Re: GVRE 52nd Ave (#1614144)/Pre-Application Meeting held March 31, 2022

On behalf of Oakwood Homes and Terracina Design, we have reviewed the comments dated April 14, 2022. The following is a response to comments.

Figure C102.1(2) HYDRANT SPACING ALONG BOULEVARDS AND HIGH-VOLUME ARTERIAL STREETS

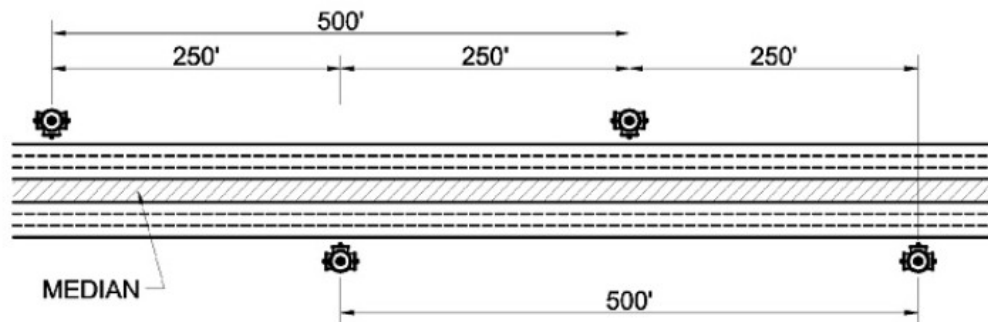
The intent of this note is to provide guidance for placing hydrants along boulevards with uncrossable medians and multilane roads that carry a heavy traffic load each day. Such roadways present the fire department with several challenges to rapidly accessing installed fire hydrants. Boulevards with built-up or walled medians can prevent ready access to hydrants if they are on the opposite side of the street from a fire incident. Accordingly, fire hydrants are required to be installed on both sides of the boulevard right-of-way. Arterial streets with high traffic flows are also problematic as accessing hydrants on the opposite side of the street presents risk to fire fighters and apparatus when leading out or manually dragging supply hoses across such busy thoroughfares. **RESPONSE: Acknowledged**

In addition to those dangers, police agencies already faced with the traffic control needs of the fire scene are often opposed to shutting down major streets for prolonged periods of time since doing so can have an adverse “domino effect” on traffic management in other areas of the community. These hydrants are typically intended for use only with highway hazards and may be spaced every 500 feet (152 m) on each

side in alternating positions [resulting in a hydrant every 250 feet (76 200 mm)] [see Commentary Figure C102.1(2)] **RESPONSE: Acknowledged**
